Servicing & Stormwater Management

Rev 1

700 Spring Valley Road
Ottawa, Ontario

November 29, 2024

drawing title Site Servicing Plan	
scale As Shown	drawn by R.Ismail
date September 2024	checked by A.Sammour
project number 24-828	drawing number C1
CONTRACTOR TO VERIFY ALL DIMENSIONS AND NOTIFY THE ARCHITECT OF ANY DISCREPANCIES BEFORE WORK COMMENCES. DO NOT SCALE DRAWINGS.	
revision

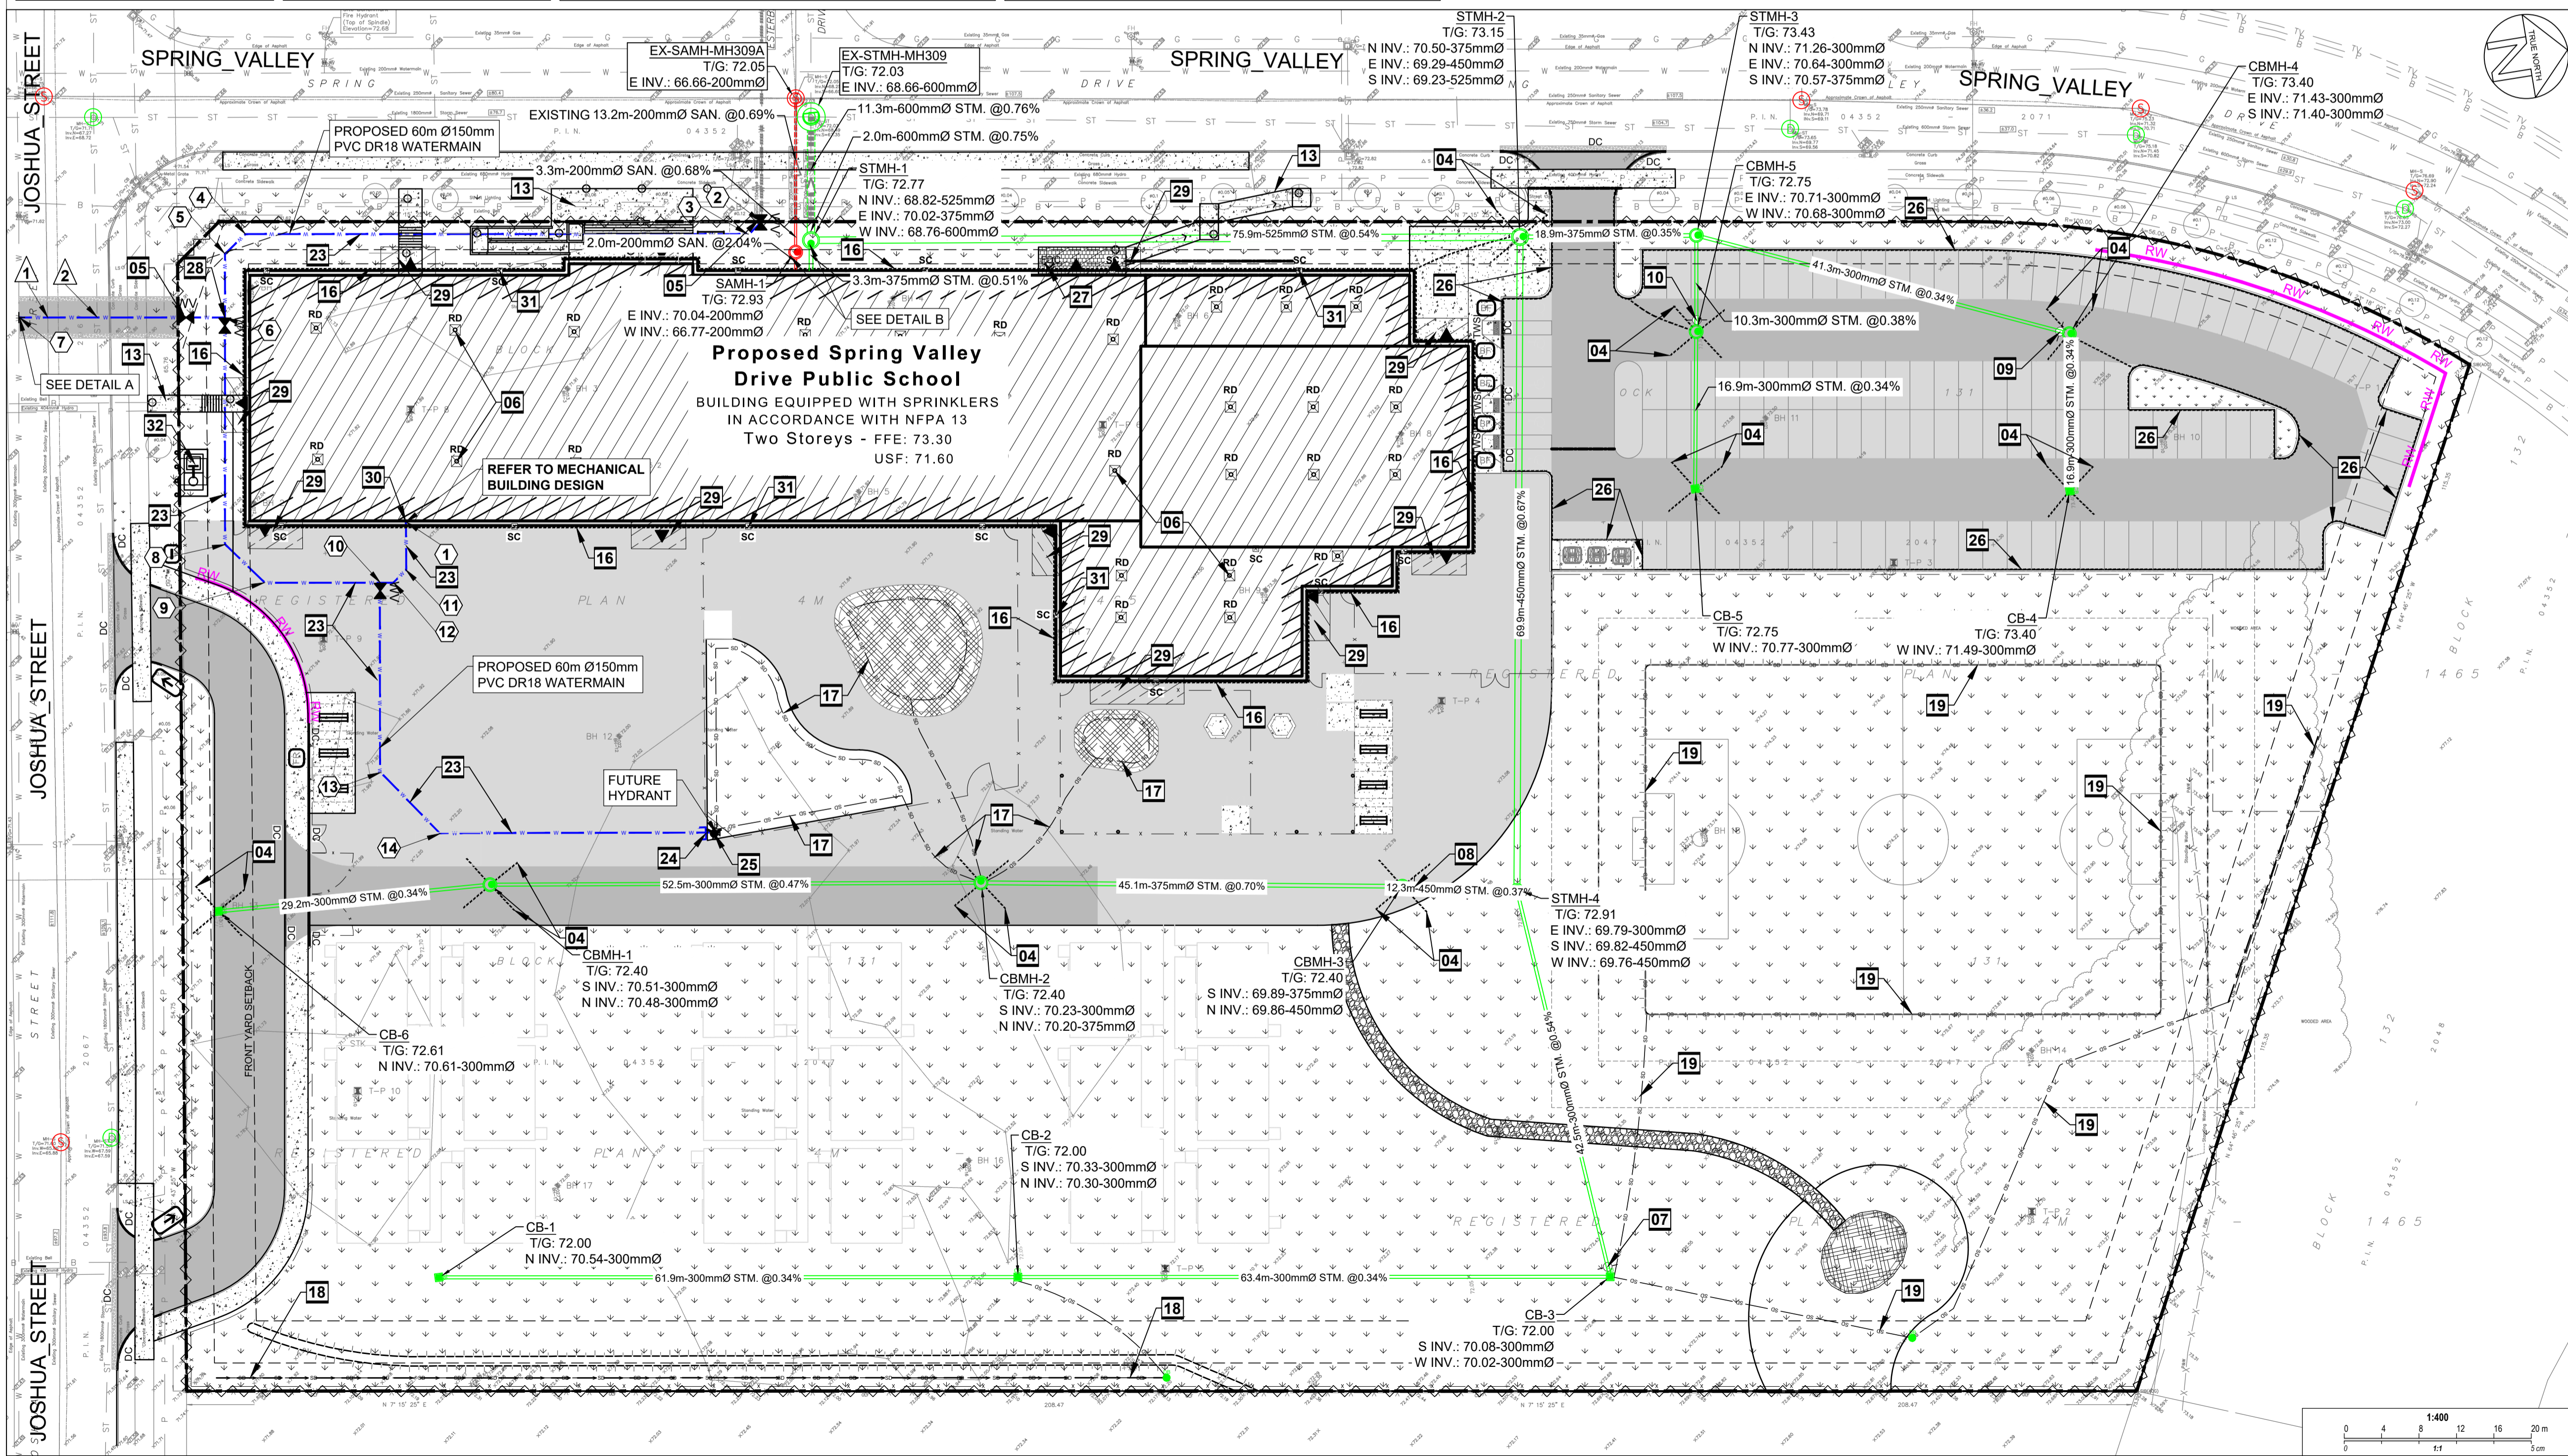
32. *Engineering comment #20c, e,:* Jp2g response acknowledged.
33. *Engineering comment #20d:* Please review and revise the design for future hydrant feed. If the watermain breaks anywhere in the highlighted location H (shown on drawing C1 comments), the fire hydrant will be out of order.

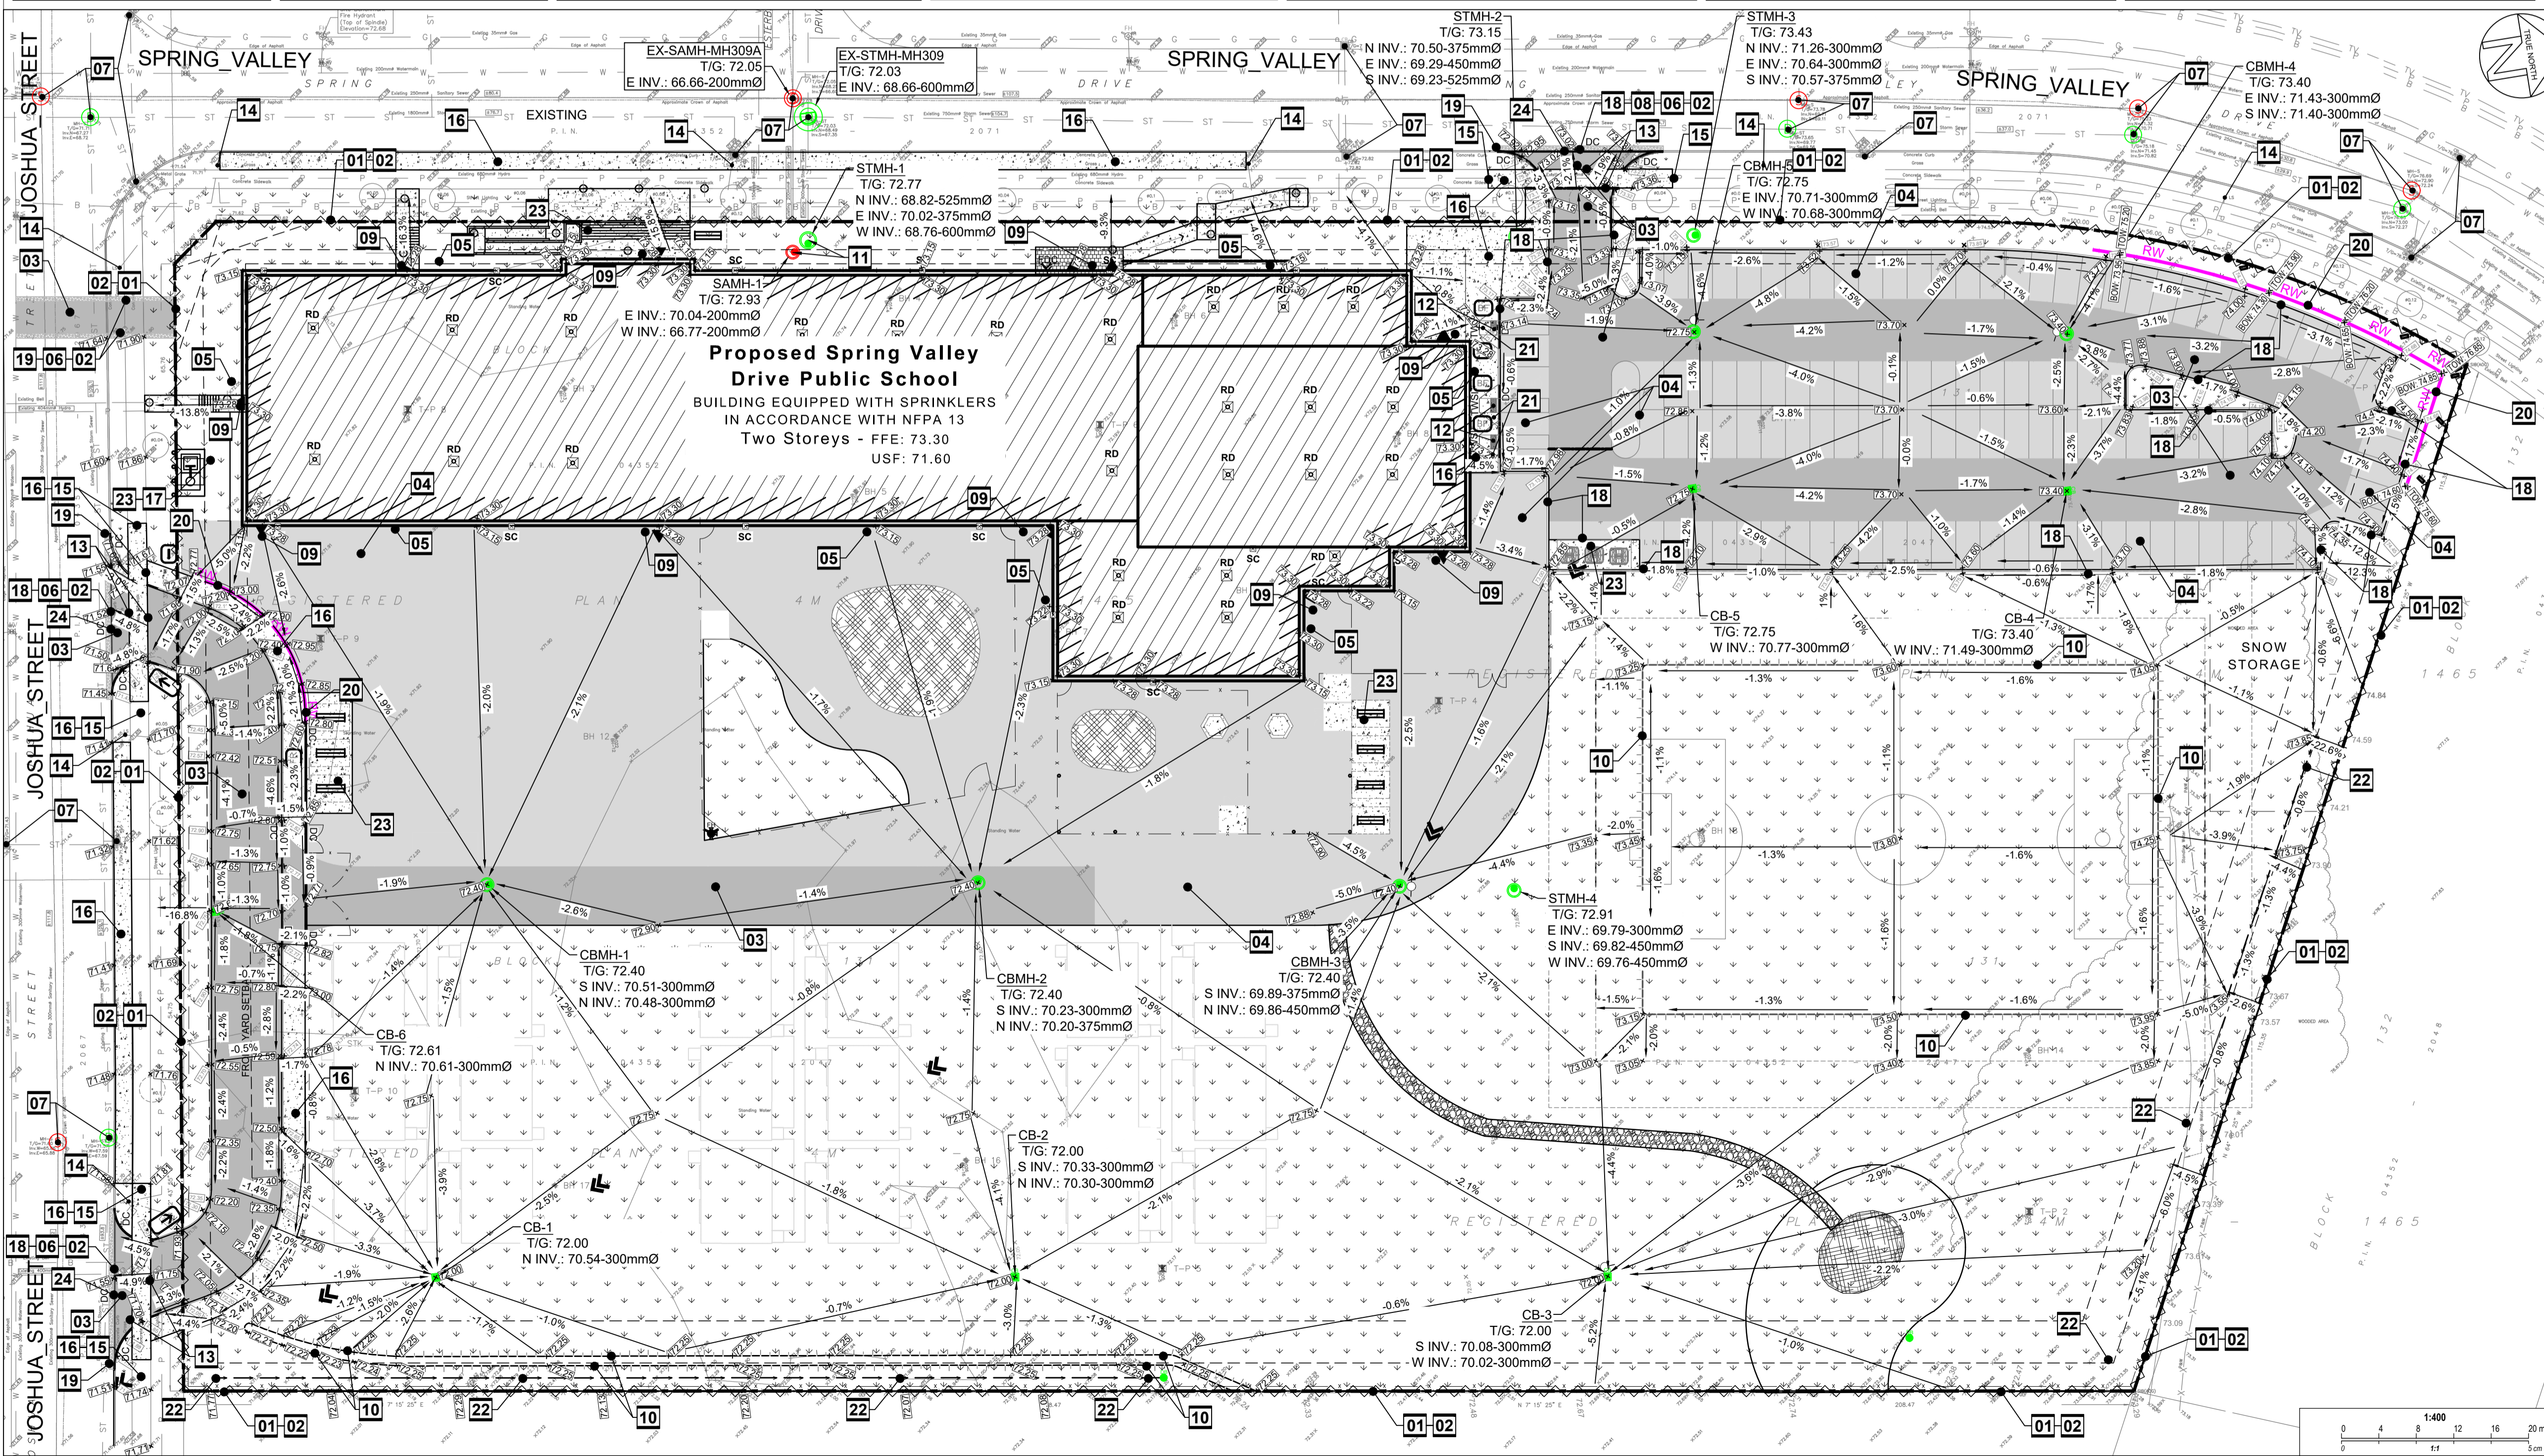
36. *Engineering comment 21b, d, e, f:* Jp2g response acknowledged.
37. *Engineering comment 21c:* Snow storage areas not shown on drawing C2 as per response, please updated drawing to show location of snow storage areas.

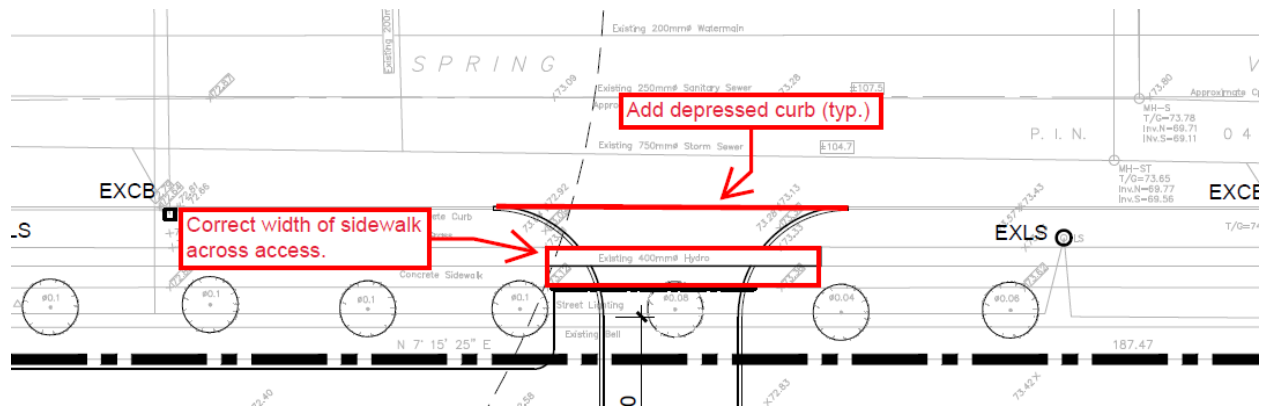
39. Landscape and Civil plans still show a layby along Spring Valley Drive and Joshua Street, revise to ensure consistency between plans.

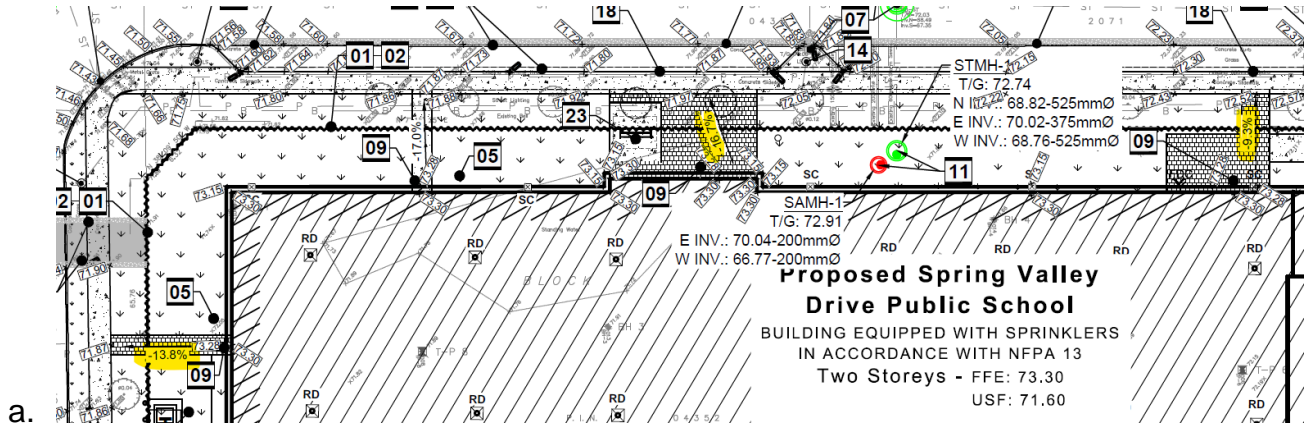
40. Comment-Response #37-g: In the site plan, correct the width of the sidewalk across the Spring Valley Drive access.
41. At all accesses, illustrate curbs at the road edge as depressed, per City of Ottawa standard drawing SC7.1. This applies to the site plan as well as the functional design in Appendix L of the TIA. Refer to markup below:

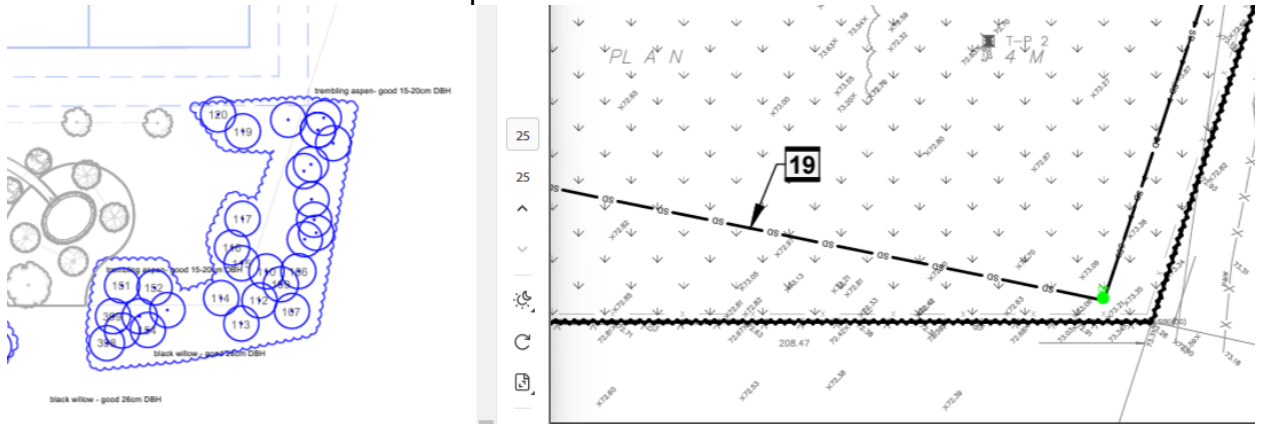
57. Tree ID numbers are missing on the Tree Conservation Plan, Map-2, photo provided:
